UNITED STATES PATENT AND TRADEMARK OFFICE

APPLICATION NO.	FILING DATE	FIRST NAMED INVENTOR	ATTORNEY DOCKET NO.	CONFIRMATION NO.
10/617,928	07/10/2003	Tue Nguyen	SIM026C	3947
23910	7590	04/20/2005	EXAMINER	
FLIESLER MEYER, LLP FOUR EMBARCADERO CENTER SUITE 400 SAN FRANCISCO, CA 94111			STEVENSON, ANDRE C	
			ART UNIT	PAPER NUMBER
			2812

Office Action Summary	Application No. 10/617,928	Applicant(s) NGUYEN ET AL.	
	Examiner Andre' C. Stevenson	Art Unit 2812

**FIG. 8**

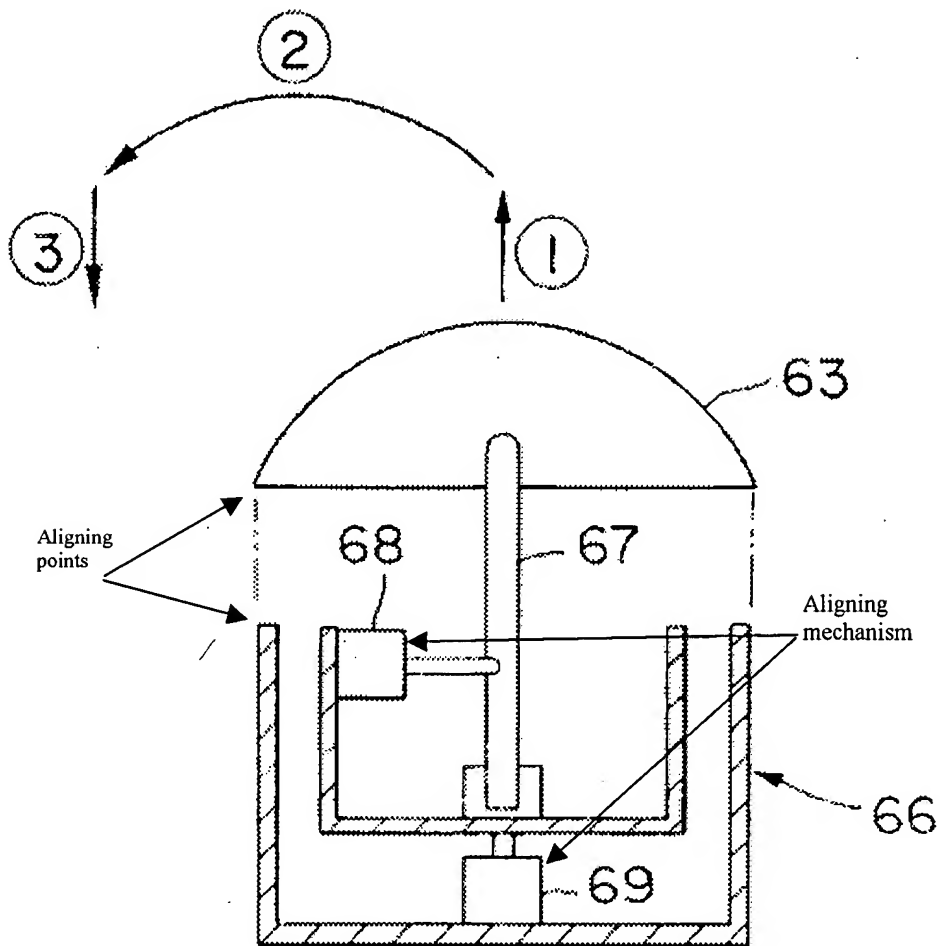
Pertaining to claim #25, Kamikawa teaches a system, further comprising a floating pivot to automatically align the lid to the body of the chamber (**column 8, lines 19-34**). The examiner recognizes that Kamikawa does not explicitly mention that the floating pivot automatically aligns the lid to the body. However, the examiner takes the position that the projection of fig #8, along with recited text above, shows that the lid is indeed automatically aligned with the body; See figure below.

It would have been obvious to one having ordinary skill in the art at the time the invention was made, to include, a system, further comprising a floating pivot to automatically align the lid to the body of the chamber, into the method of Pang, as taught by Kamikawa, with the motivation that a pivot that automatically align itself would insure a air tight closing before any further operations.
